Best Buy Premium Design Center

Conversion

MAVD TO MDC (PDC)

Plan outline for converting MAVD electronics to MDC (aka PDC) configuration

827-003 RECEIVERS 9-16
BEFORE

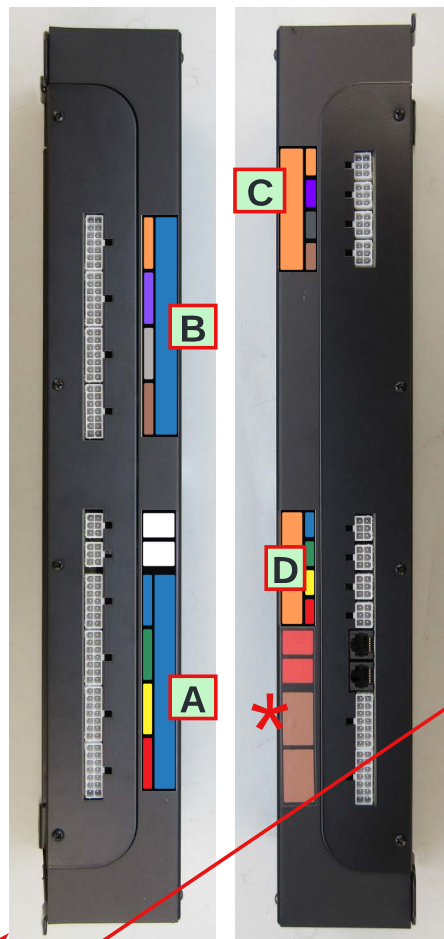
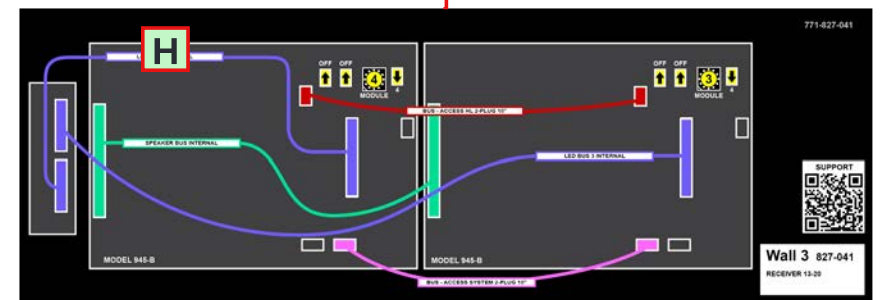
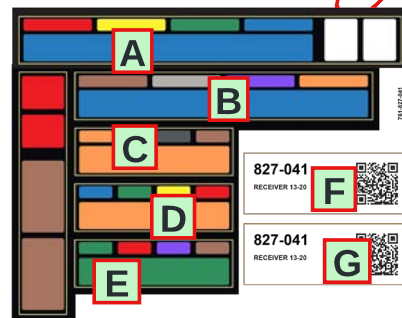
NEW ADDRESS
SETTING = 3

NEW ADDRESS
SETTING = 4

APPLY COLOR CODE
OVERLAYS ON
OUTSIDE OF LID

APPLY NUMBER
OVERLAYS ON BASE
AND COVER

APPLY WIREMAP
OVERLAY INSIDE LID

**HOW TO CHANGE 827-003
TO 827-041 (RECEIVERS 13-20)**
REPLACE OVERLAYS AND **CHANGE ADDRESSES** AS NOTED ABOVE

827-006
REC 1-16 HDMI

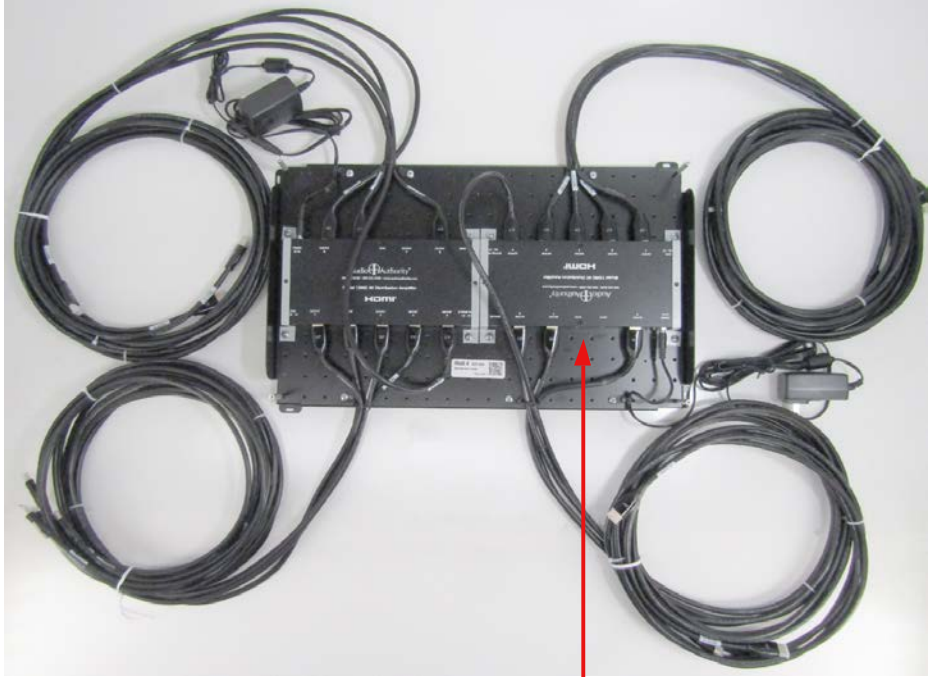
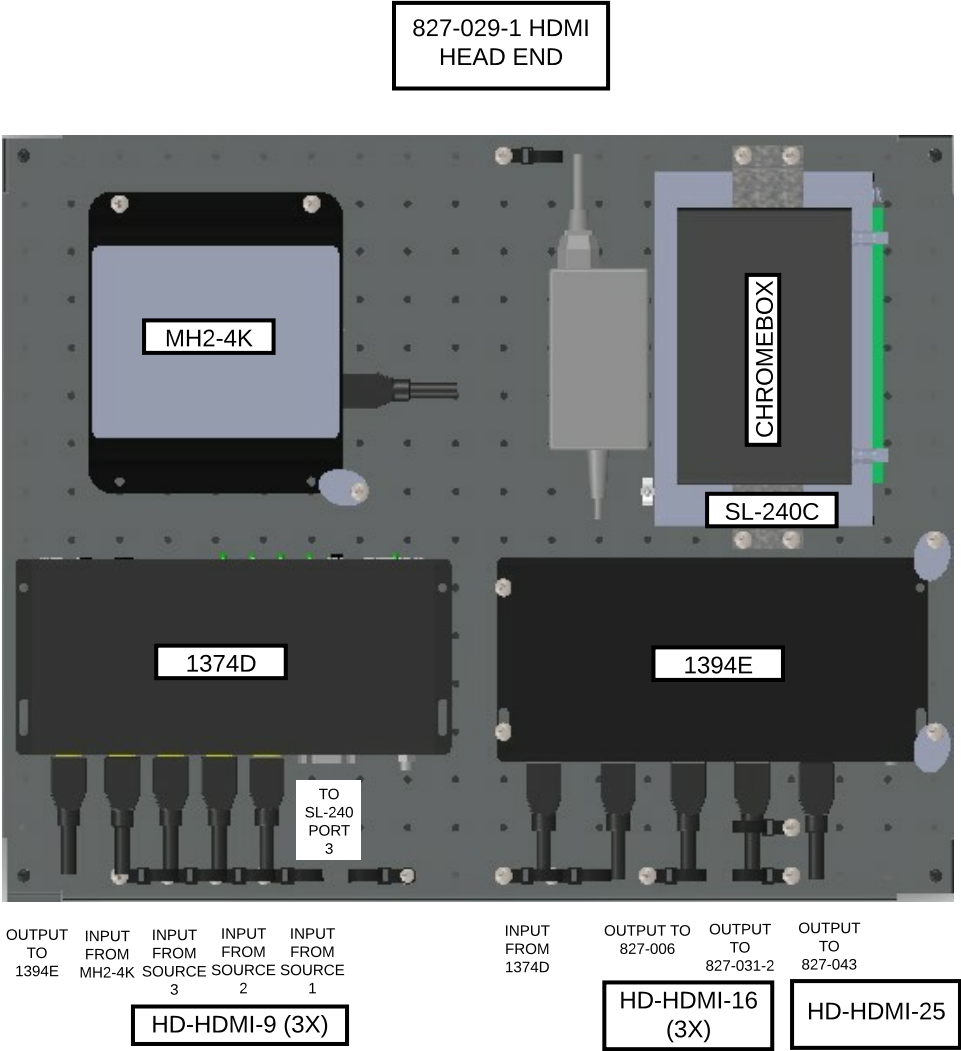
APPLY NUMBER
OVERLAYS INSIDE
AND OUTSIDE

REMOVE HDMI CABLES
REC 13-16

APPLY NUMBER
OVERLAYS INSIDE
AND OUTSIDE

HOW TO CHANGE 827-006
TO 827-032 (RECEIVERS 1-12 HDMI)
REPLACE OVERLAYS AND **CHANGE CABLES** AS NOTED ABOVE

HOW TO CHANGE 827-029-1 TO 827-029 (HDMI HEAD)

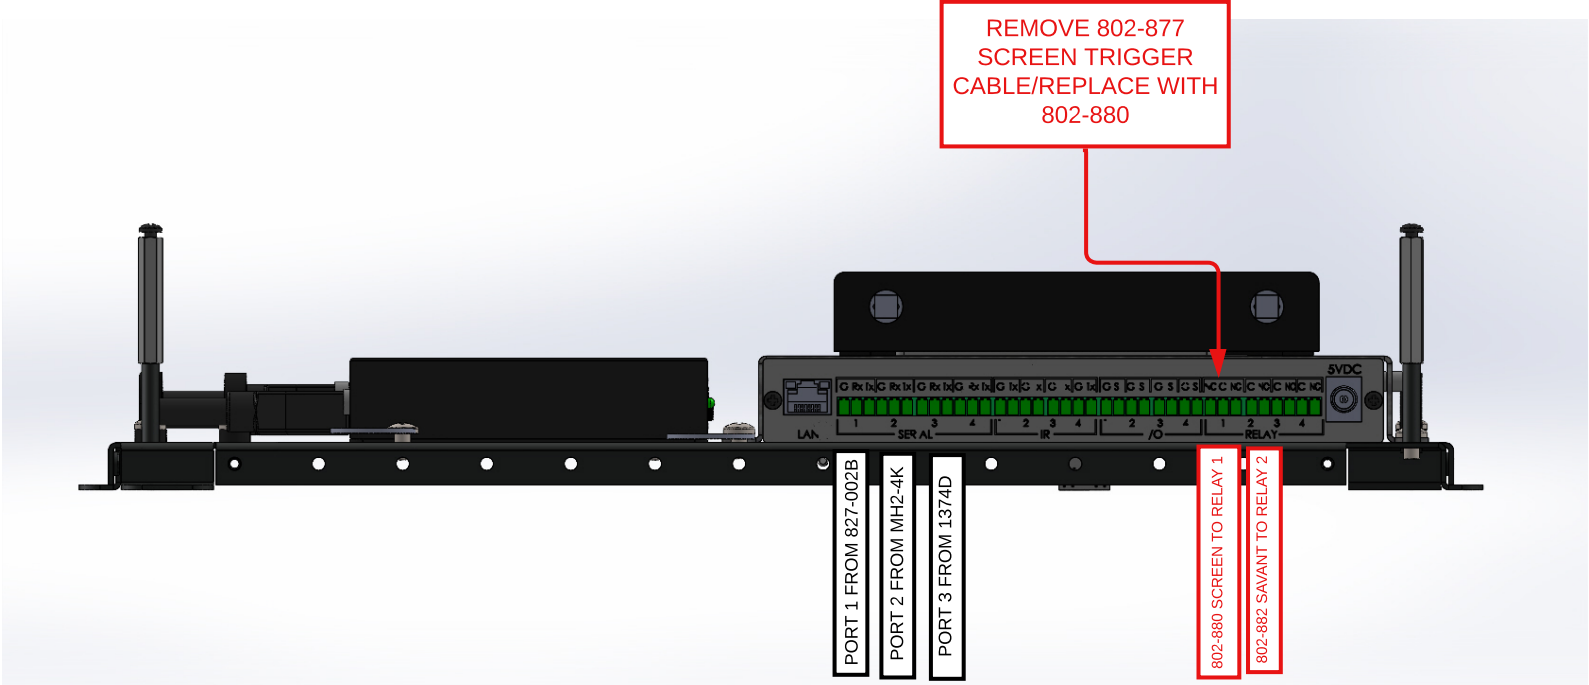
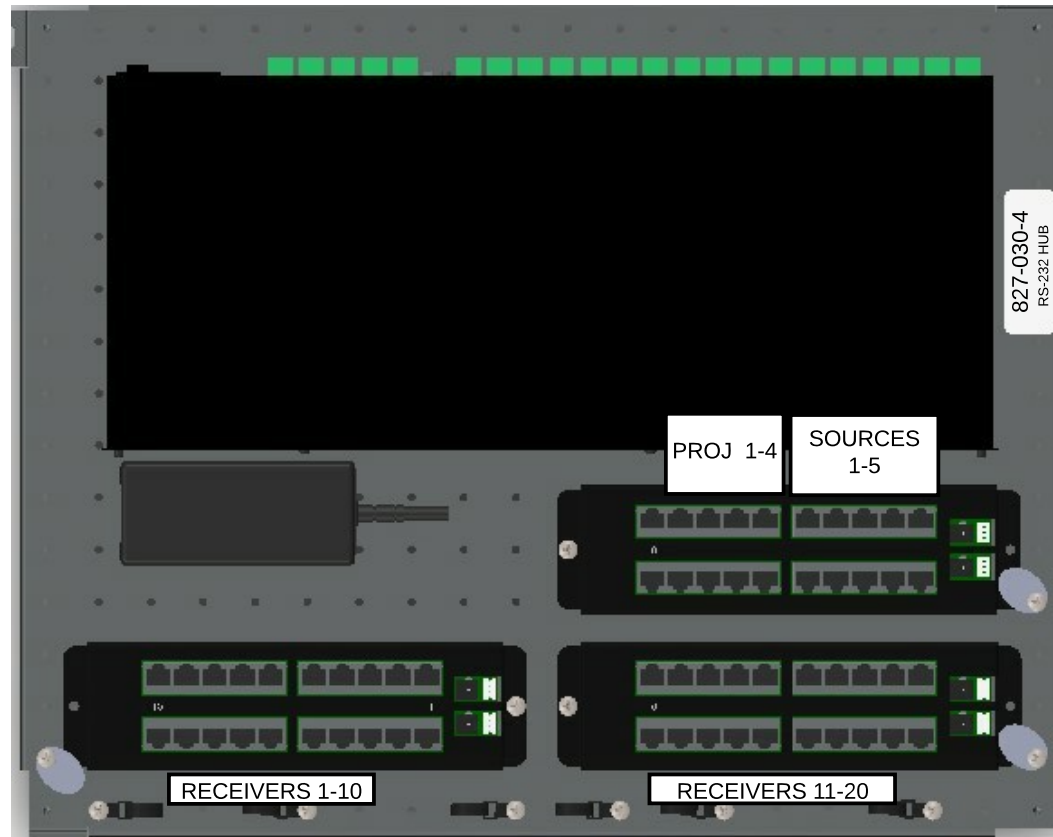
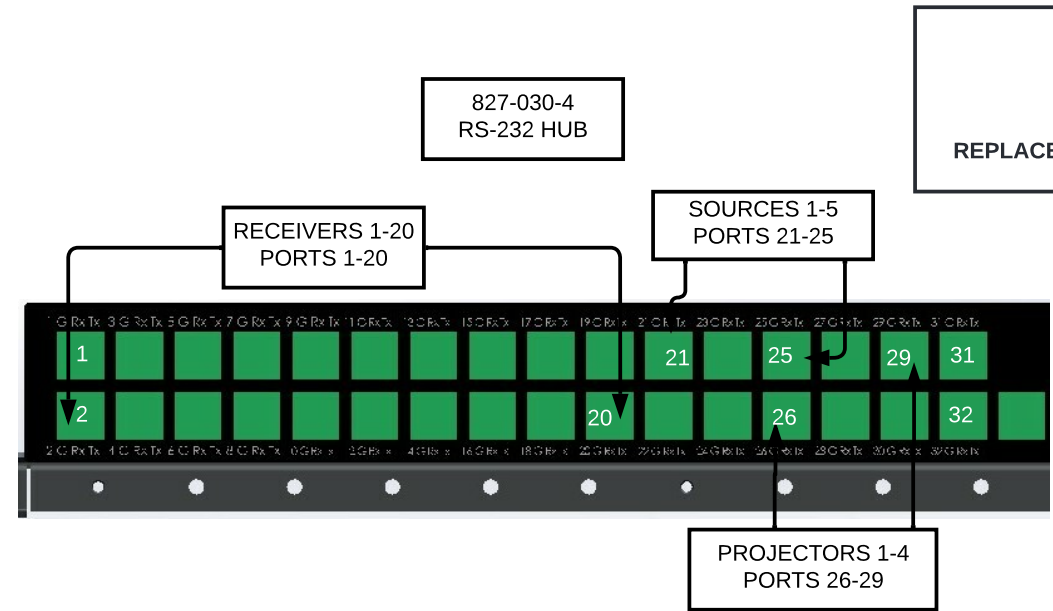
APPLY NUMBER OVERLAYS INSIDE AND OUTSIDE

HD-HDMI-16 (2X) TO 827-032

REMOVE HD-HDMI-16 REPLACE WITH HD-HDMI-25 TO 827-043

MOVE HD-HDMI-25 REPLACE WITH HD-HDMI-50A TO WALL 3 827-032-1

REMOVE 802-877 SCREEN TRIGGER CABLE/REPLACE WITH 802-880

REPLACE OVERLAYS AND **CHANGE CABLES** AS NOTED ABOVE

HOW TO CHANGE 827-030-4
TO 827-030 (RS-232 HUB)

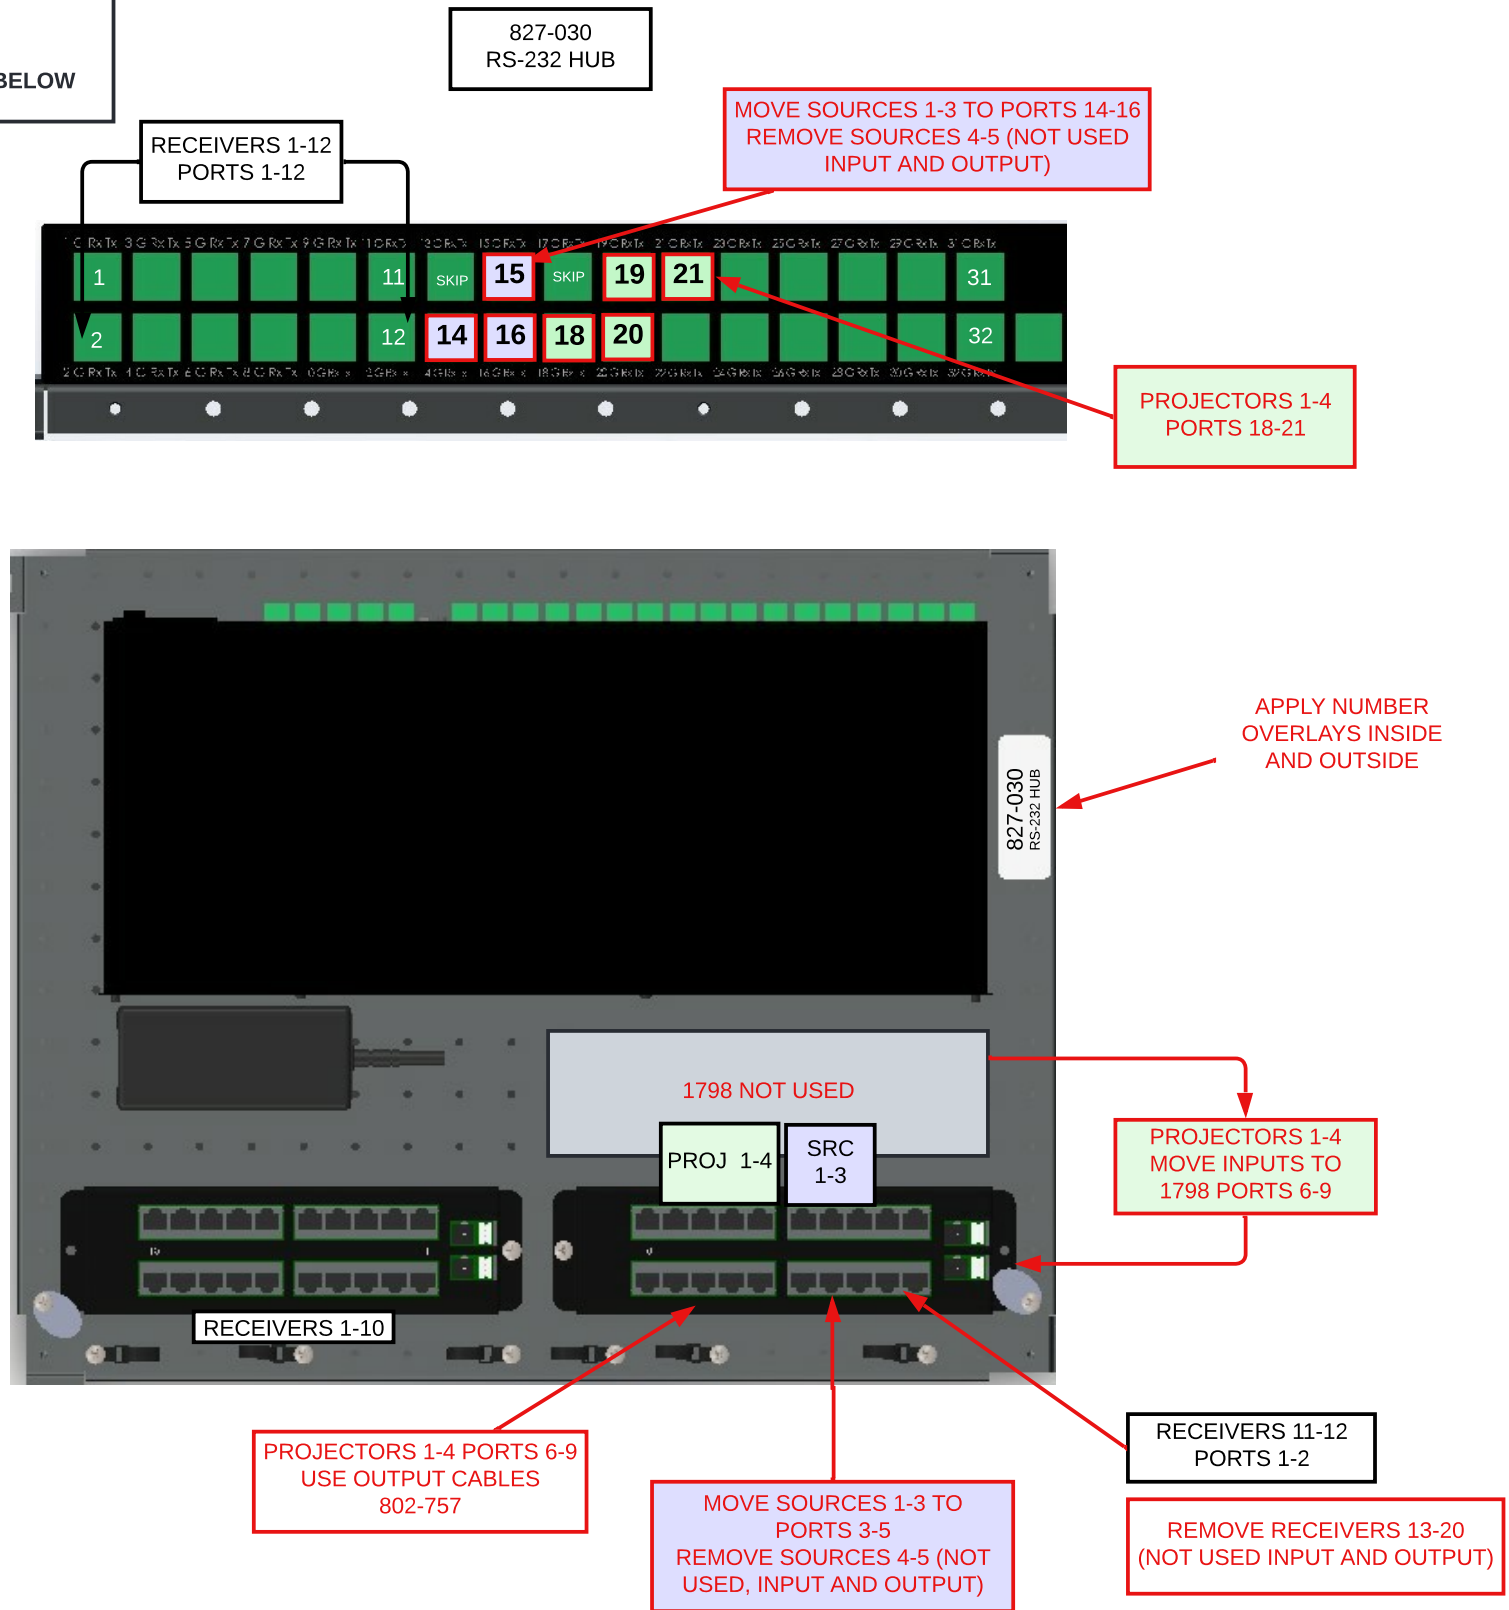
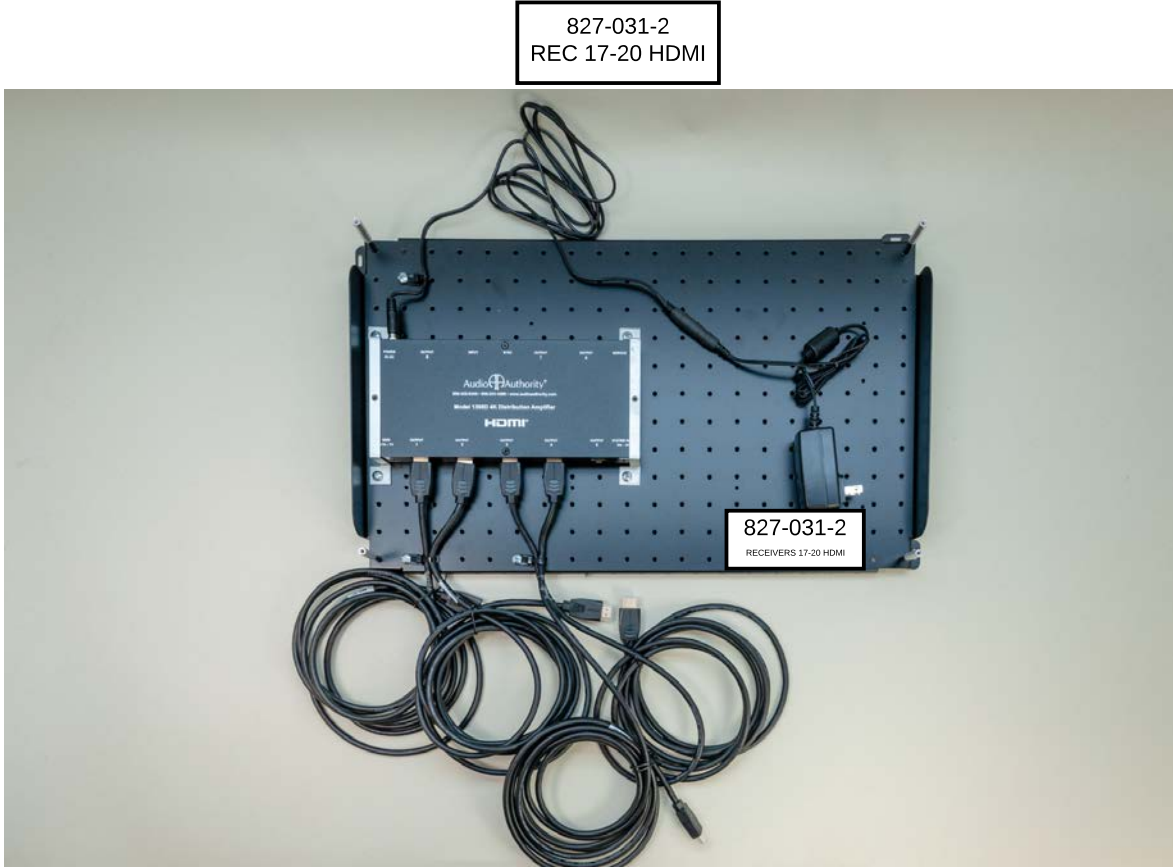
HD-HDMI-9 (4X)

APPLY NUMBER
OVERLAYS INSIDE
AND OUTSIDE

REPLACE OVERLAYS AND **CHANGE CABLES** AS NOTED BELOW

**HOW TO CHANGE 827-031-2
TO 827-032-1 (RECEIVERS 13-24 HDMI)**

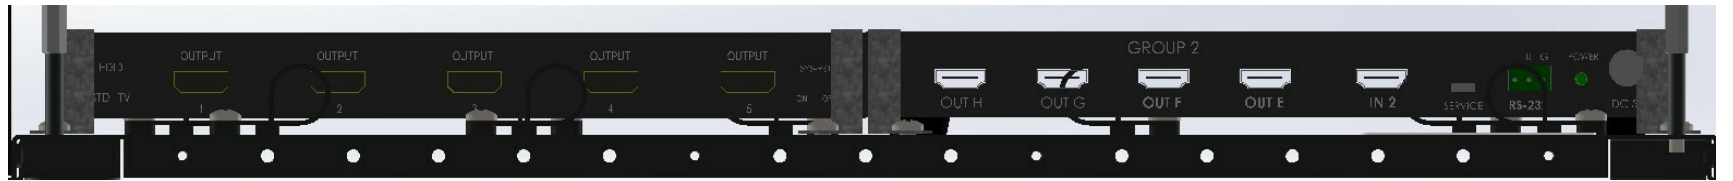
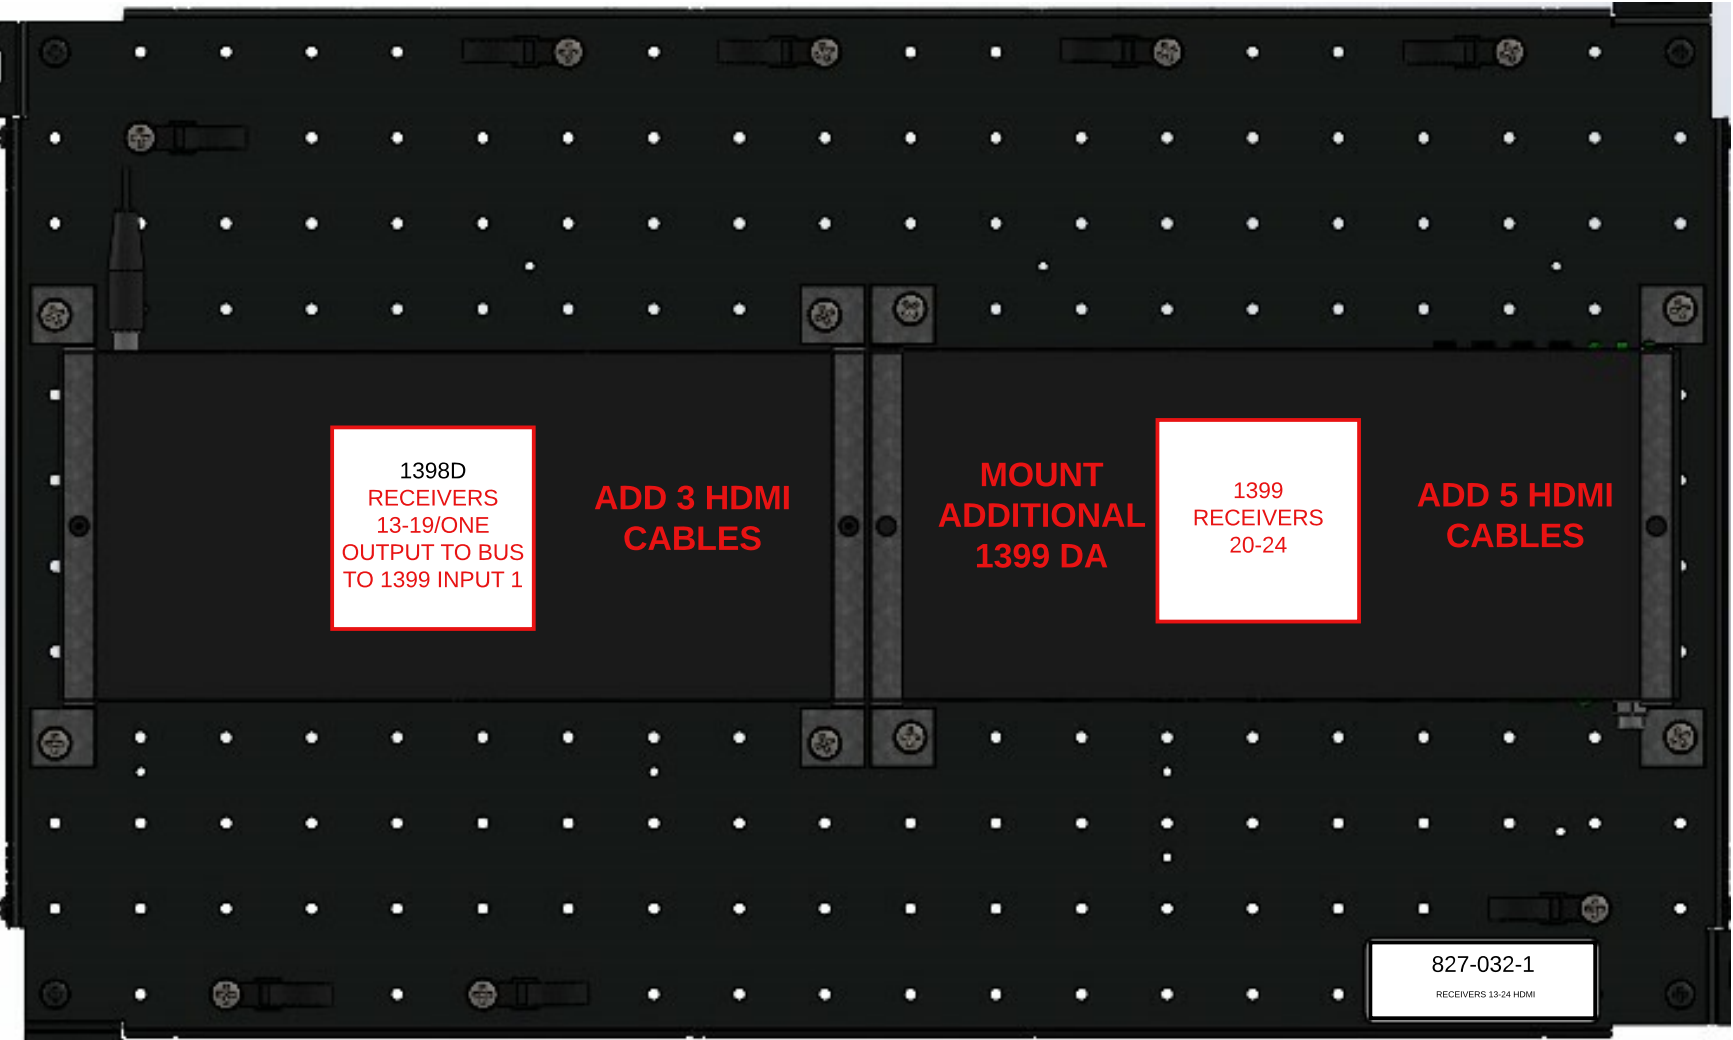
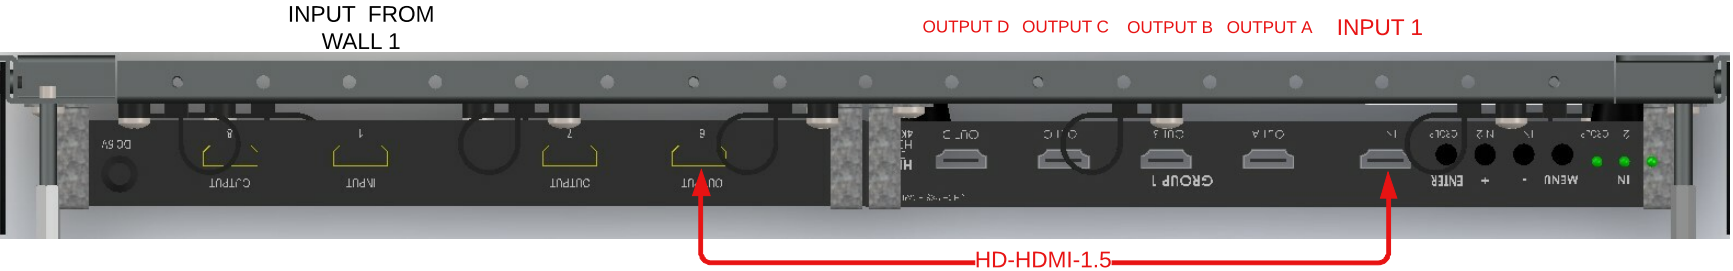
**ANY OUTPUT TO
ANY RECEIVER**

OUTPUT E

REPLACE OVERLAYS AND **CHANGE CABLES** AS NOTED ABOVE
